**SUBDIVISION, PLANNED UNIT DEVELOPMENT, &
PLANNING APPROVAL STAFF REPORT****Date: February 1, 2007****DEVELOPMENT NAME**

Pala Verde Mobile Home Park Subdivision

APPLICATION NUMBER 10 & 11 & 12 DATE February 1, 2007
APPLICANT Pala Verde Partners
REQUEST Subdivision, Planned Unit Development, Planning Approval

SITE PLAN

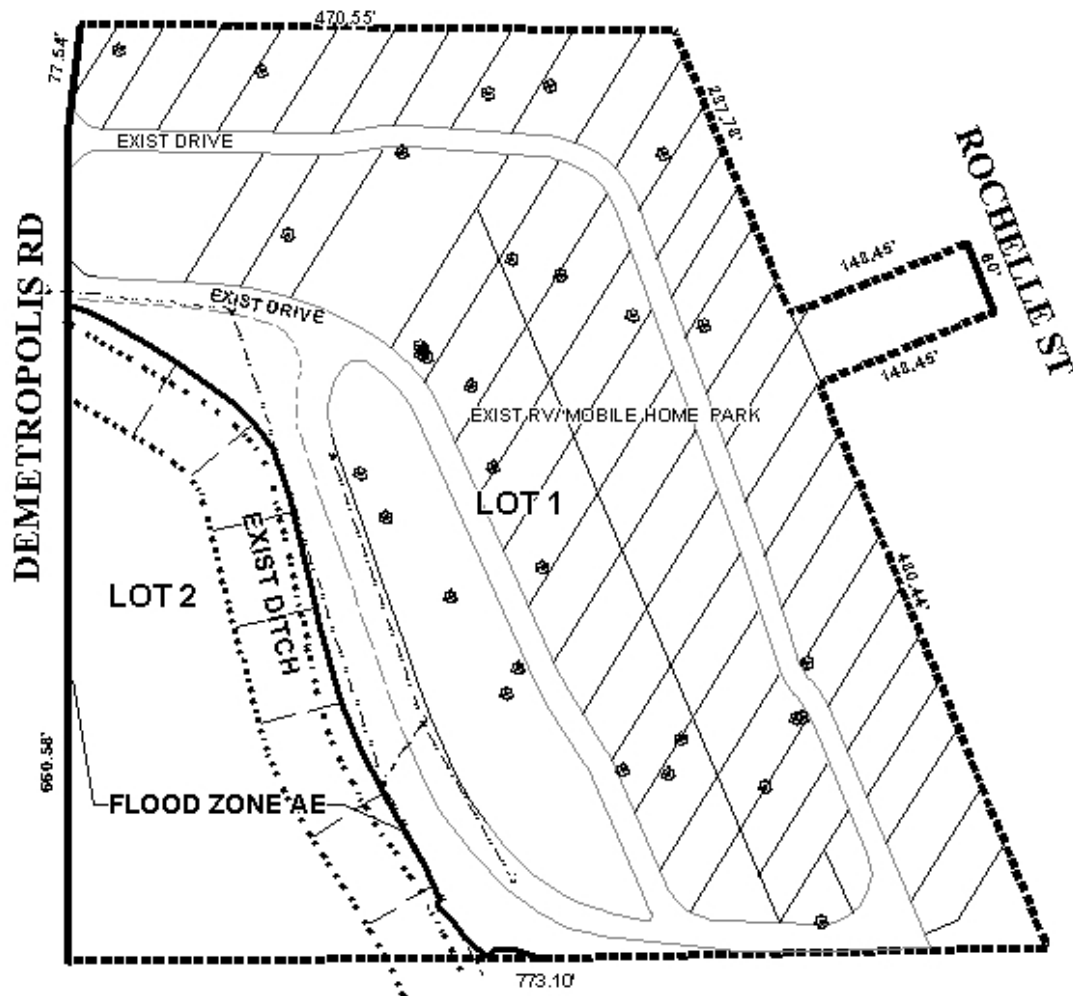
Show drainage easement. The flood zone shown should be depicted from FEMA maps NOT plotted from elevations. Show minimum finished floor elevation on lots. The applicant is responsible for verifying if the site contains wetlands. The site can be checked against the National Wetlands Inventory on the COM web site Environmental Viewer. If the site is included on the NWI, it is the applicant's responsibility to confirm or deny the existence of regulatory wetlands.

Driveway number, size, location, and design to be approved by Traffic Engineering and conform to AASHTO standards. Driveway width is narrower than the standard for two-way traffic flow. The driveway width should be widened to twenty-four feet or the drive should be signed and marked for one-way travel.

Additionally, as illustrated Lot 30 of Brooks Manor Subdivision is included in the proposed Lot 1 of the preliminary plat. However, it should be removed as this legal lot of record is zoned R-1, Single-Family Residential, fronts a residential minor street, and is not "part" of the development.

Since the site is providing 52 spaces for mobile homes 52 spaces would be required for the site. However, if the site provides an on-site rental office, one space per 300 square feet for the rental office would be required. Therefore, prior to the signing of the Final Plat a revised PUD plan should be submitted illustrating the required parking spaces for the rental office.

Regarding circulation on the site, most aspects would meet the requirements of the Zoning Ordinance. However, the site has an approximate 17-foot circular access on-site, which could not accommodate two-way traffic. As Traffic Engineering states if this is a desirable alternative for access, the driveway and circulation aisle must be signed and marked to restrict it to one-way traffic.

Also, the plan does not illustrate landscaping and tree plantings, it has been the practice of this Commission to require landscaping and tree planting for such areas on other similar projects.

Planned Unit Development Based on the preceding, the PUD is recommended for Approval, subject to the following conditions: 1) completion of the subdivision process; 2) provision of the required buffer fence where the site abuts residentially zoned properties; 3) any significant changes to the site development will necessitate a new PUD approval by the Planning Commission; 4) Full compliance with landscaping and tree requirements for Lot 1; 5) submission of a revised PUD plan illustrating the required parking for

the on-site rental office and the exclusion of Lot 30 of Brooks Manor Subdivision; and 6) full compliance with all municipal codes and ordinances.
